**Mercedes  
Ball Joint**

**Sidem Nr.  
49383**

**Reference nr.  
211 330 03 35**

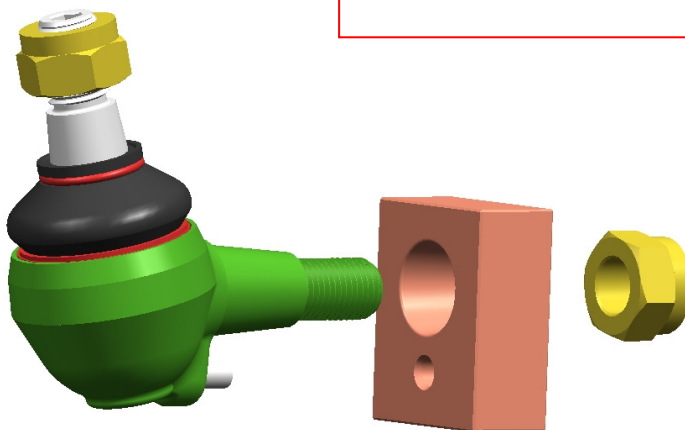
**Problem:**

- Difficult mounting
- Location of “positioning pin” is not OK.

**Solution:**

- Use of specific drilling tool to ensure the correct drilling position and angle.
- Test caliber is used to apply 100% control on correct position pin.
